# TOYOTA CUSTOMER SERVICES

Subject: 2001 to Early 2004 Model Year Toyota Highlander Child Protection Lock System

SUBJECT: **ADVANCED NOTIFICATION** – SPECIAL SERVICE CAMPAIGN (SSC) – 40B  
(2001 TO EARLY 2004 MODEL YEAR TOYOTA HIGHLANDER CHILD PROTECTION  
LOCK SYSTEM)

**TECHNICAL INSTRUCTIONS**  
**FOR**  
**SPECIAL SERVICE CAMPAIGN 40B**  
**2001 - 2004 MY TOYOTA HIGHLANDER**  
**CHILD PROTECTION LOCK SYSTEM**

## II. LOCATION OF AFFECTED PARTS

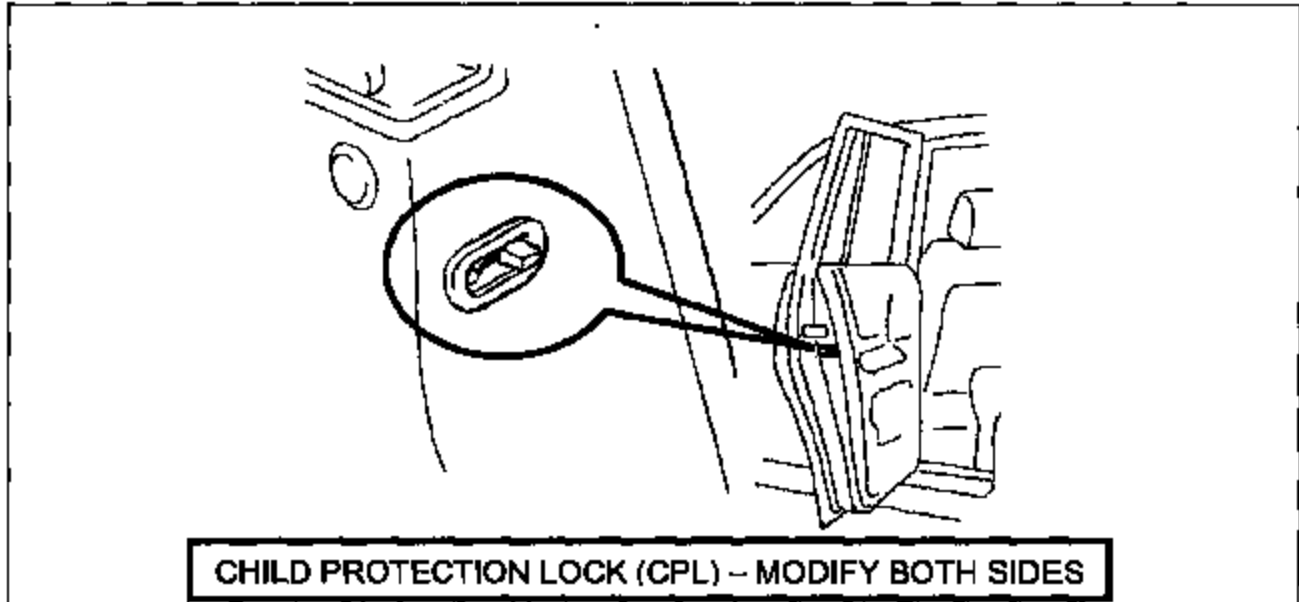
- The 2001 to early 2004 Model Year Highlander vehicles have a CPL system in both of the rear side doors. When an operator of the vehicle closes the door very hard with the CPL lever being in the lock position, there is a possibility that the lock lever may contact the body panel, causing the CPL lever to move into the unlock position. This condition could allow the door to be opened with the inside door handle while the operator believes that the CPL was activated.

**A2:** There is an insufficient amount of clearance between the CPL lever and the body panel.
